Mary Ave Villas Project

Supplemental Report

CITY COUNCIL STAFF REPORT SUPPLEMENTAL

Agenda Item #8

SECTIONS C005.0

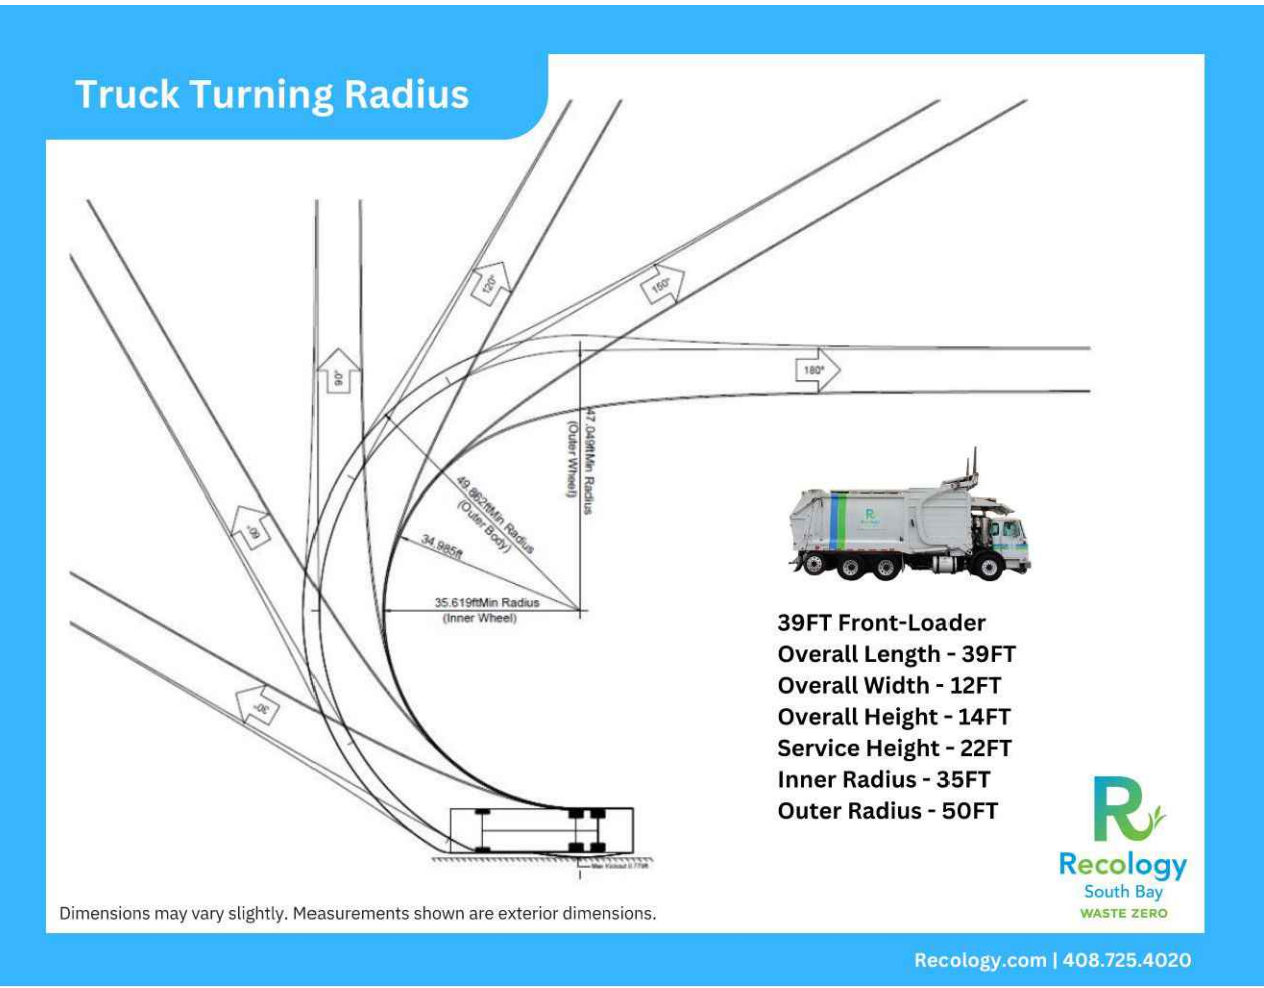
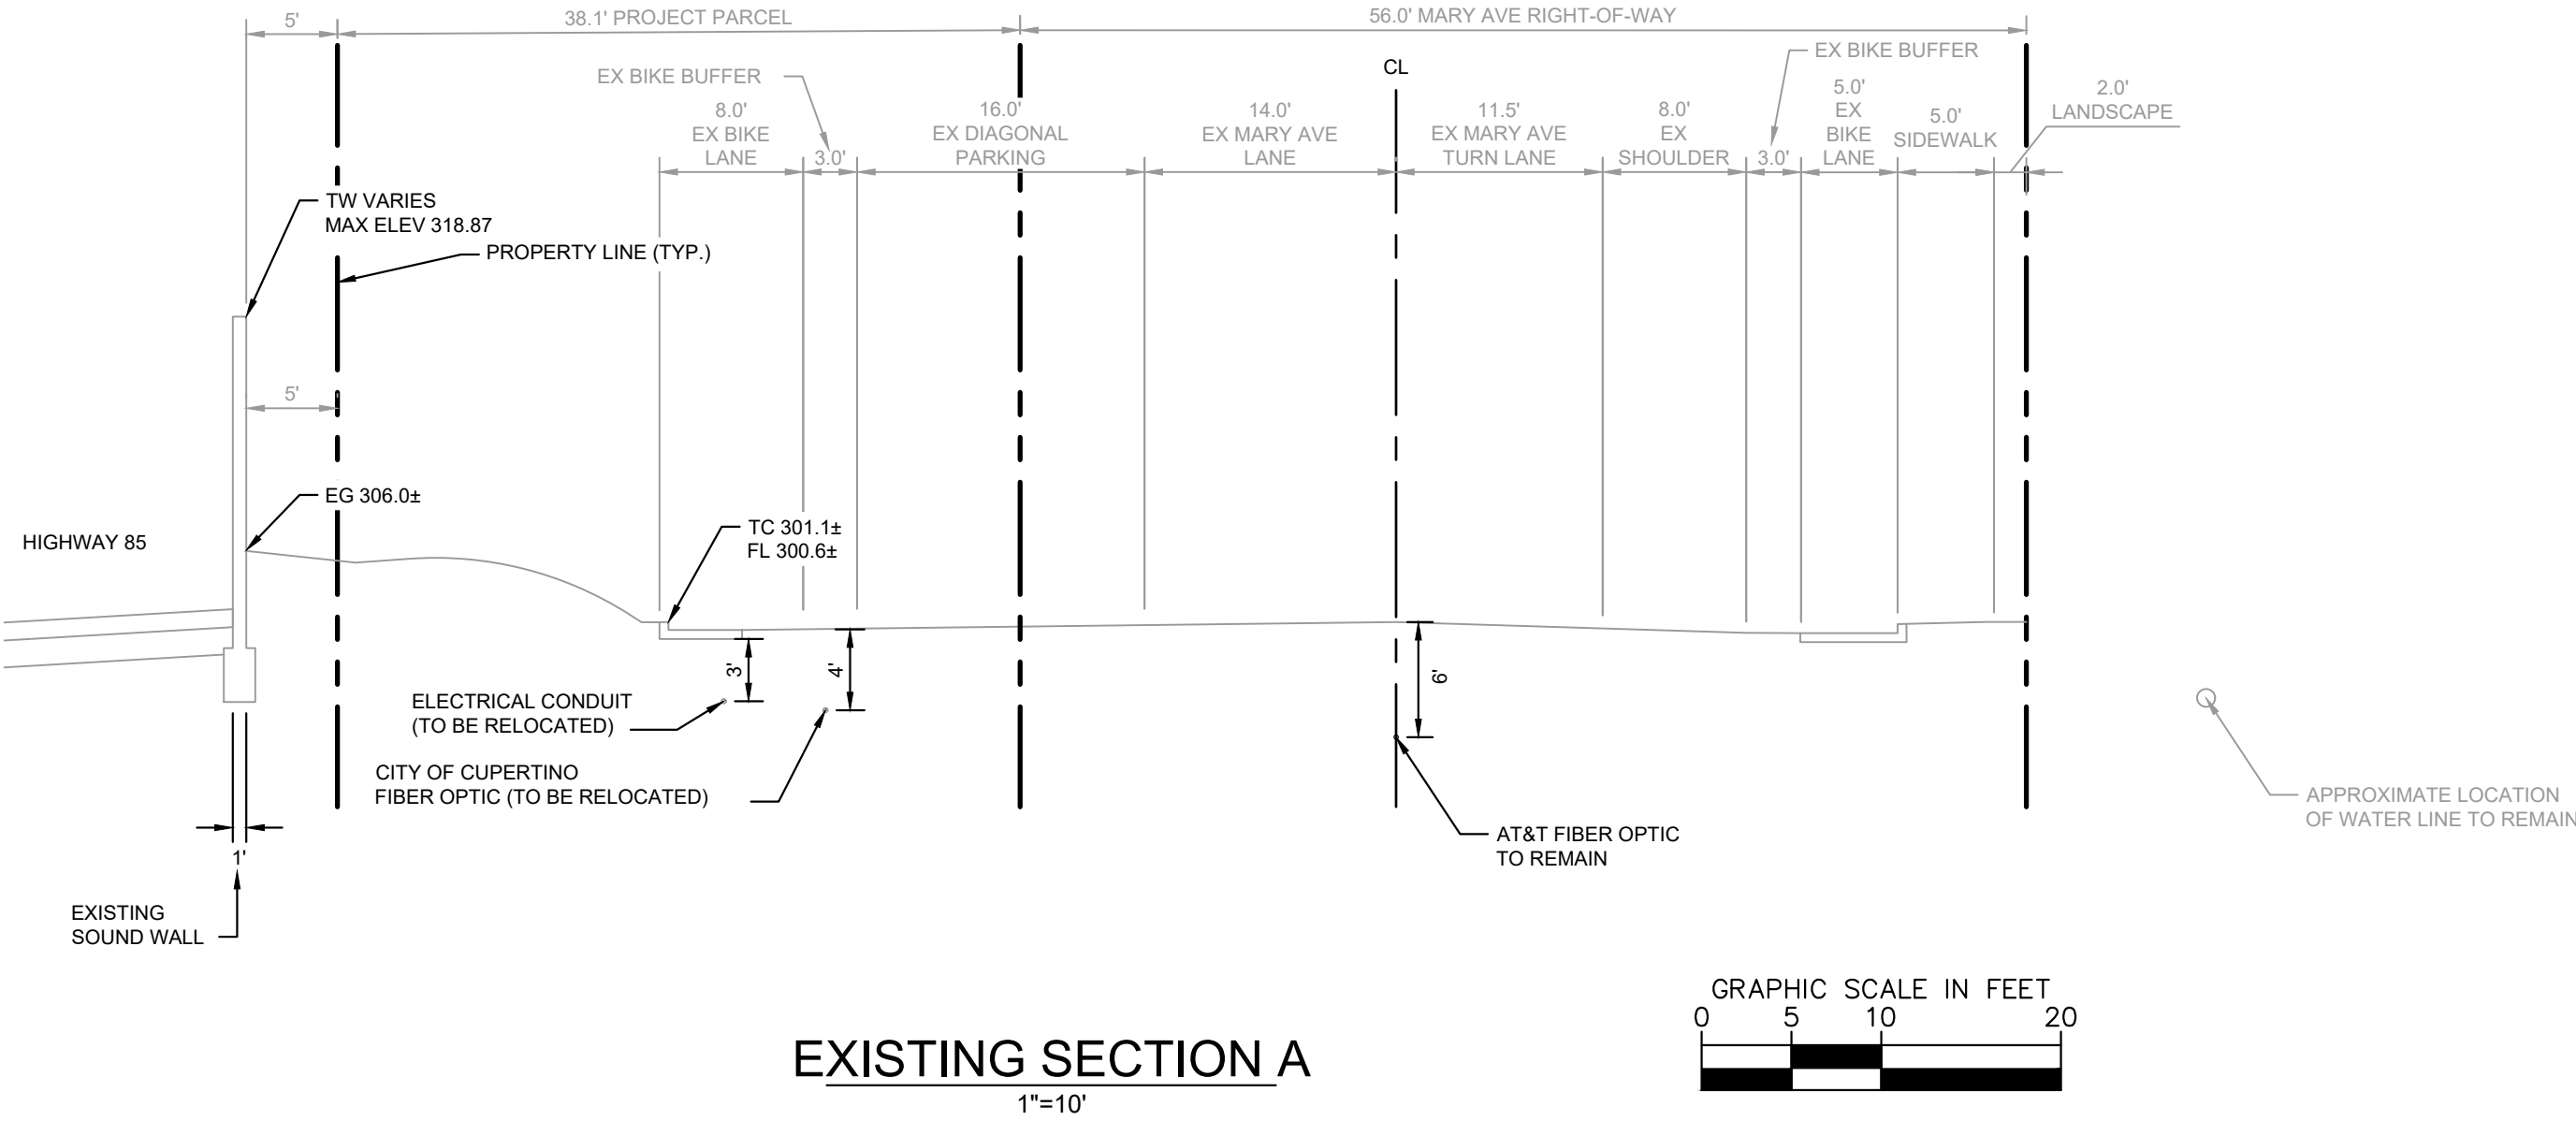
Q4: What exactly would be reconfiguration of the Mary Avenue? Please provide clear images for before and after.

Staff response: The Plan Set provided with the Staff Report (Attachment F) showed the existing conditions as well as the proposed layout of the Mary Avenue Right-of-Way. Supplemental Attachment G shows sheets C000.0 (Existing Conditions and Demolition Plan), C001.0 (Preliminary Site Plan), and C005.0 (Sections), which had been included in the Plan Set that had been provided with the Staff Report.

PARCEL MAP

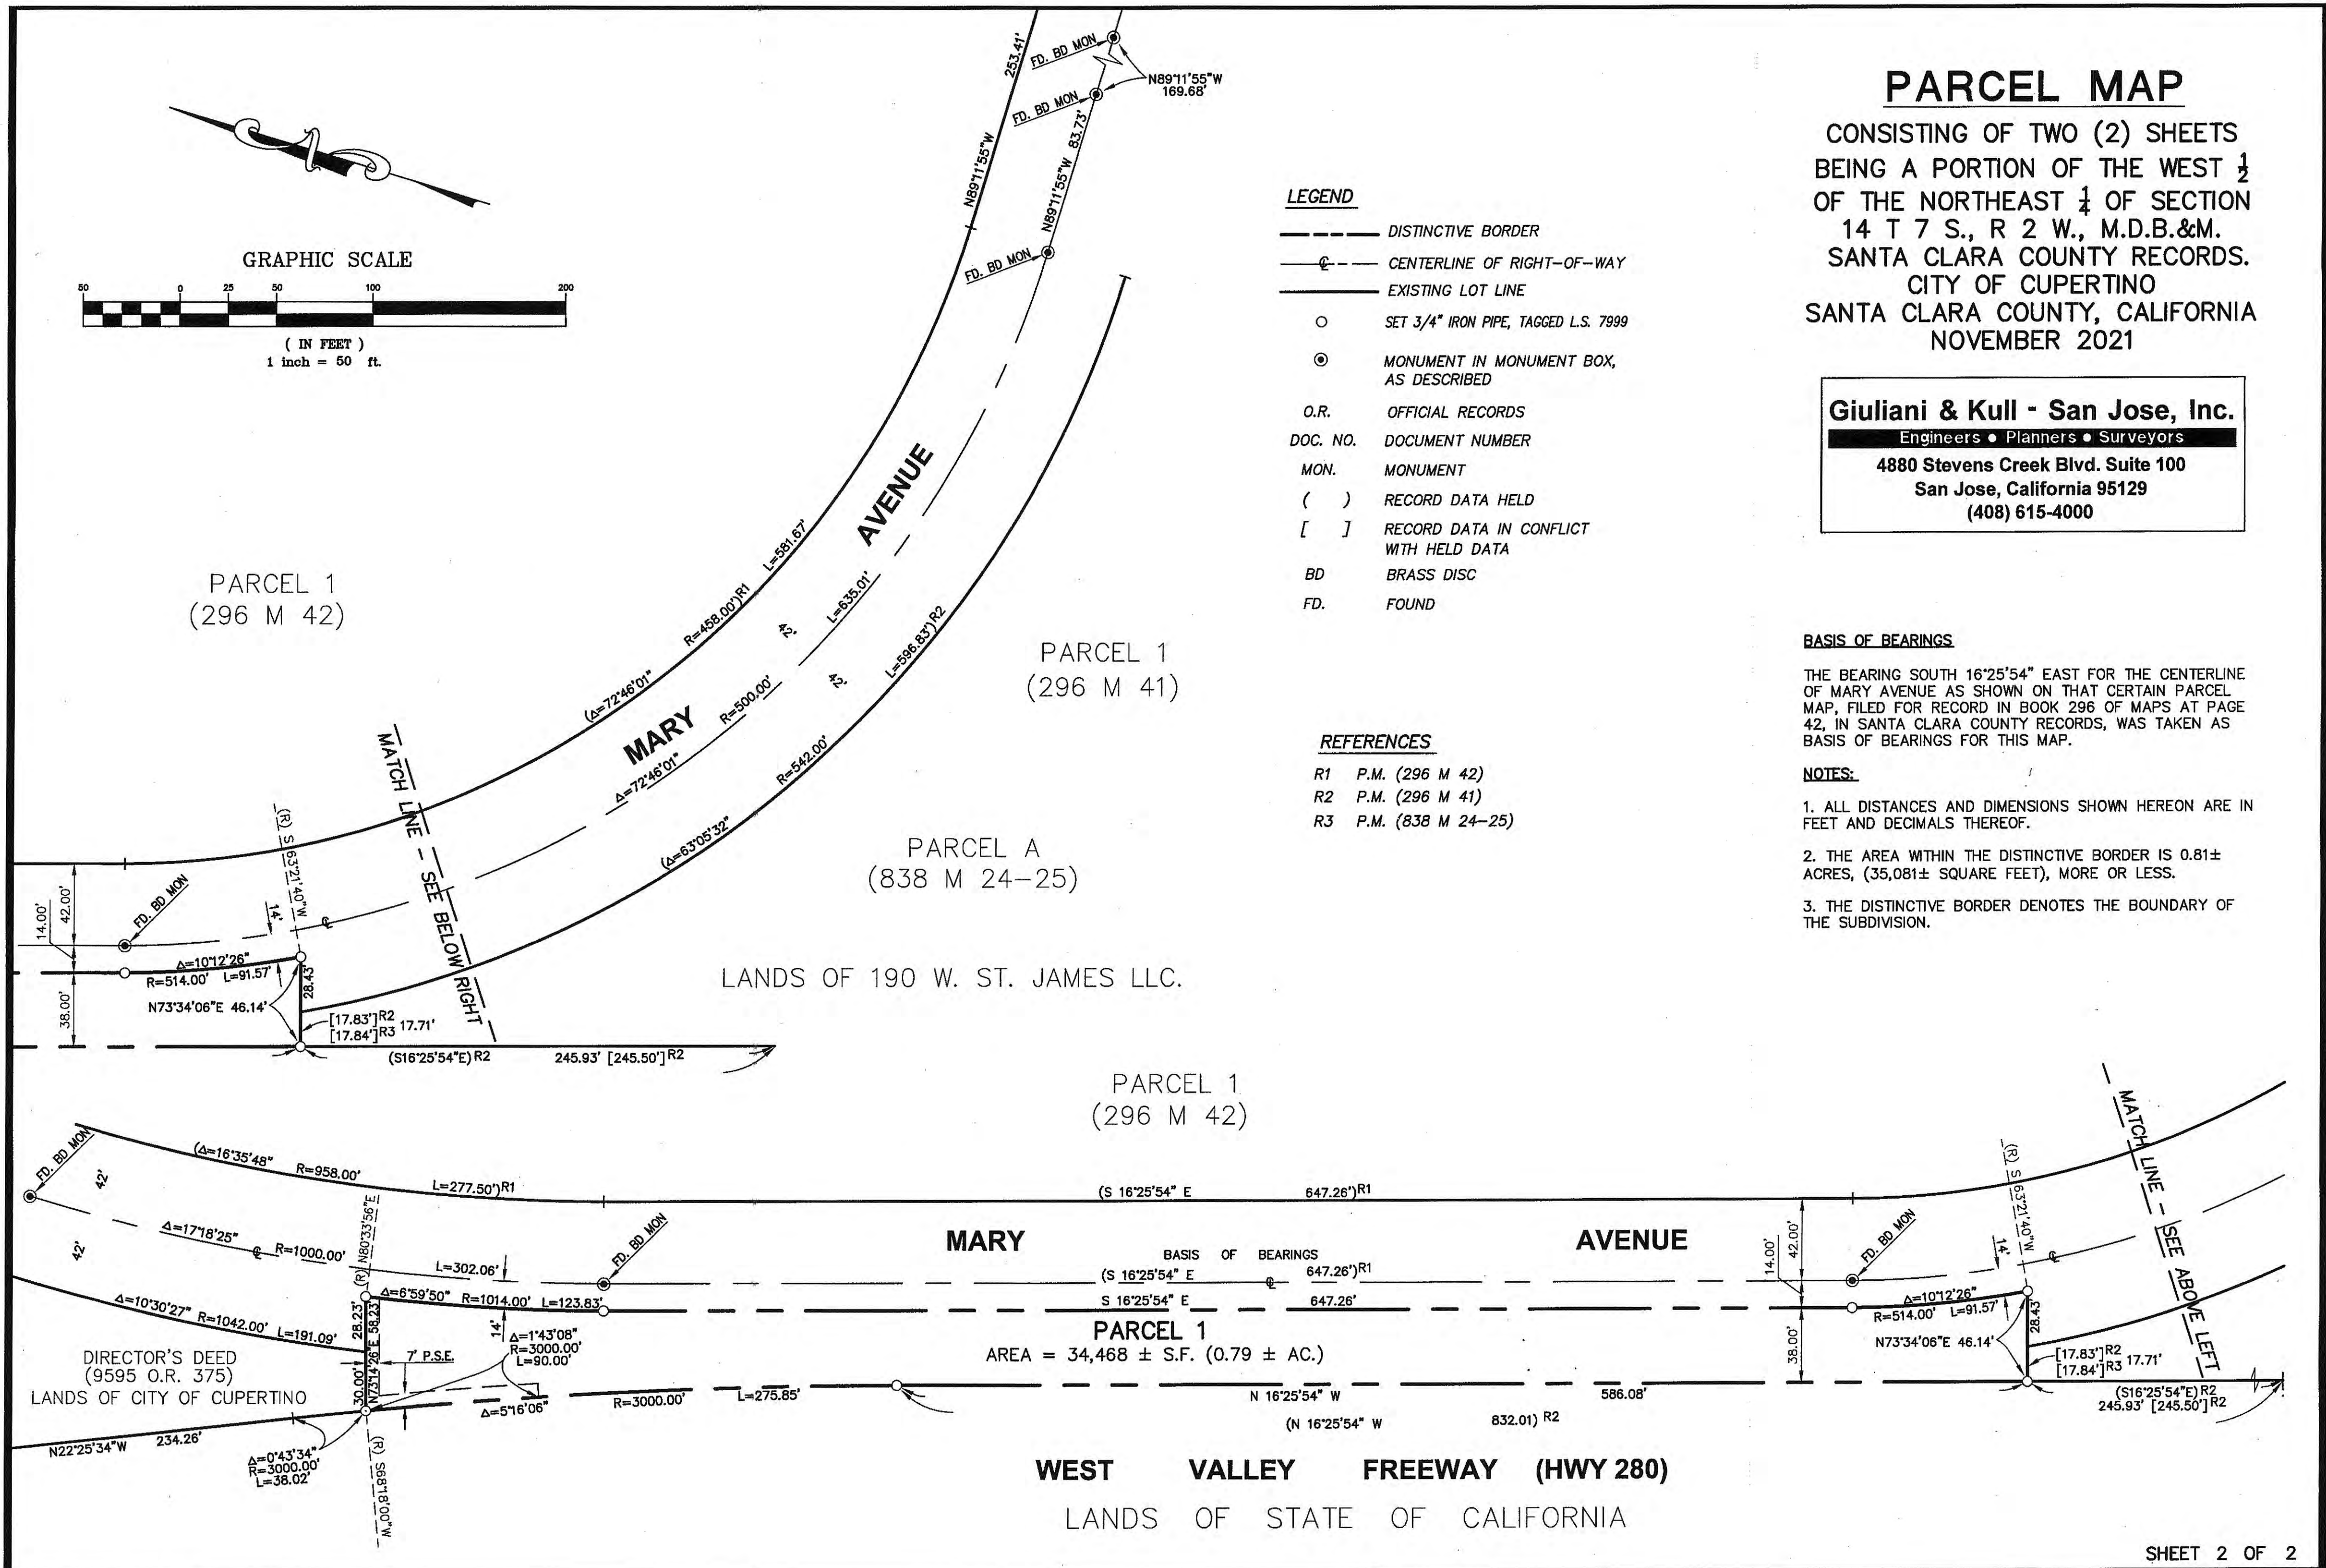
Q6: What exactly would be vacated from the Public Right of Ways? There was no map included in this agenda and no map of the Public Right of Ways on to be vacated the 1/27 Planning Commission agenda. It's unclear what exactly is the dimension of the Public Right of Way to be vacated.

Staff response: Sheet C000.0 shows the property line of the parcel to be vacated (Supplemental Attachment G). Further, Supplemental Attachment H (Parcel Map) shows a clean dimensioned parcel without the proposed development and/or existing conditions overlaying onto the sheet.

Figure 7
Proposed Parking Lot Plan

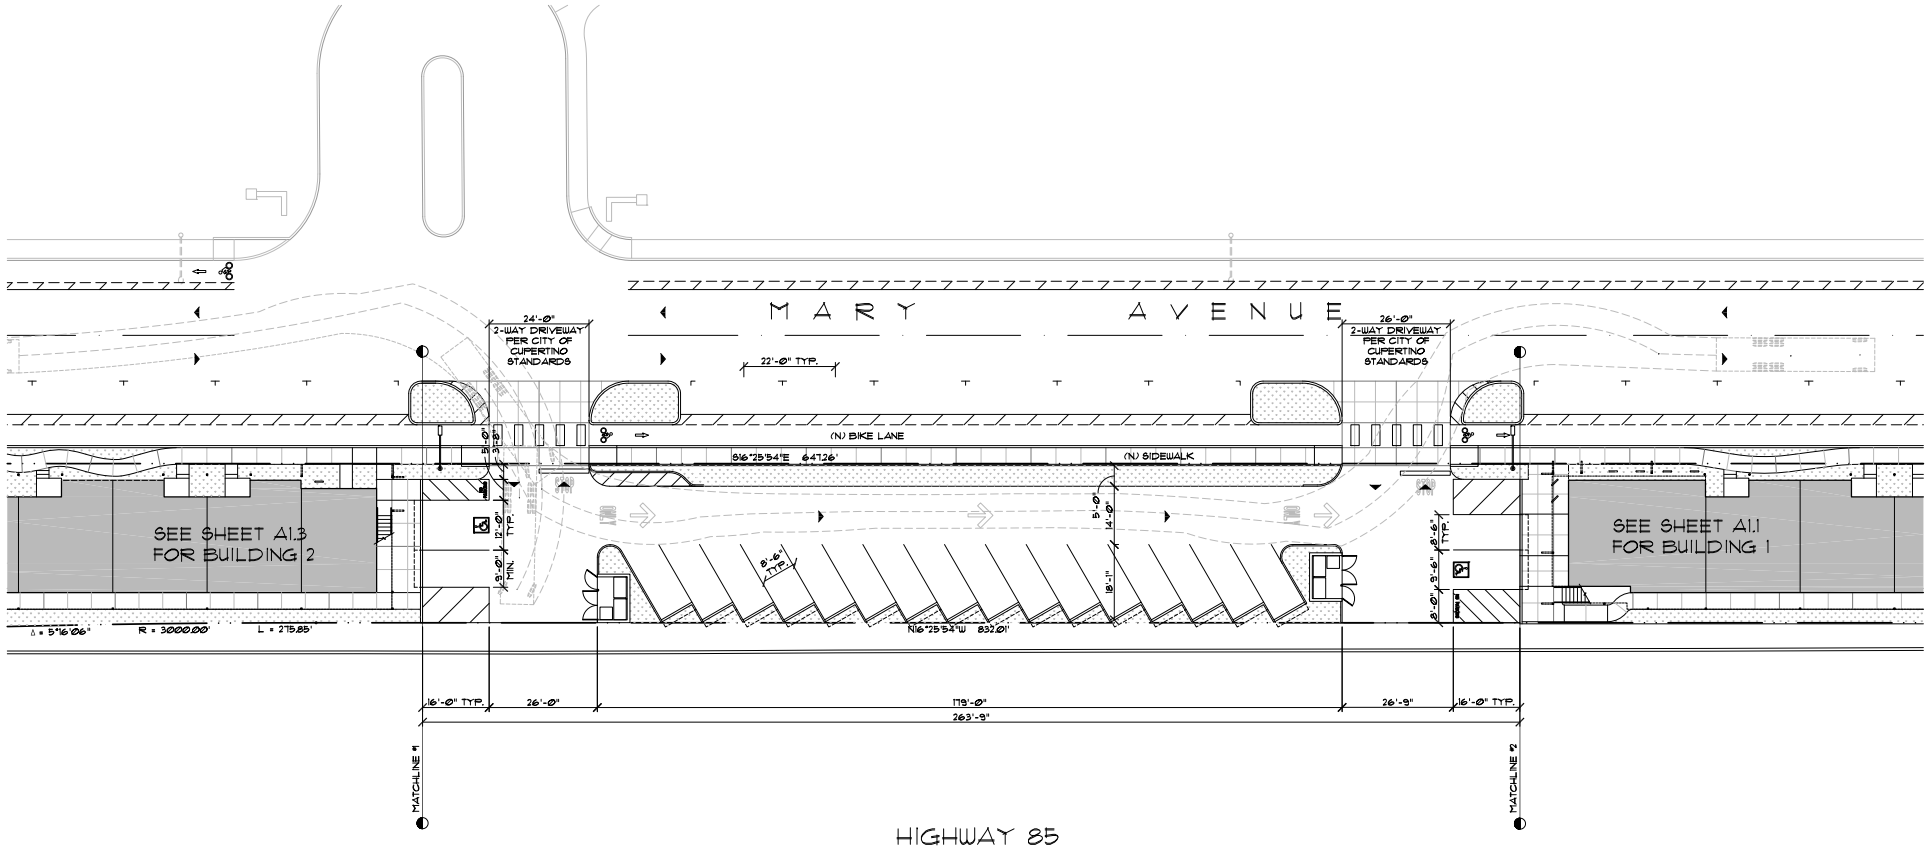
Per Table 19.124.040(B), a one-way aisle to access 60-degree angle parking spaces should be a minimum of 13 feet wide. Based on the proposed parking lot plan, the 60-degree angle parking spaces would be 8.5 feet wide, 18 feet long, and have a one-way aisle that is 14 feet wide. Thus, the project's angled parking spaces would meet the City's minimum requirements.

Concrete trash pads/enclosures are shown in the parking lot. All garbage collection activities would occur on-site. Garbage trucks would need to pull into one of the driveways, perform garbage collection activities, back out onto Mary Avenue, and pull into the other driveway to perform the rest of the garbage collection activities. The truck would encroach onto the opposite travel lane when turning into and out of the driveways. However, because of the relatively low volumes on Mary Avenue, it is not expected that this would cause any operational issues. Figure 7 shows site access and circulation for garbage trucks.
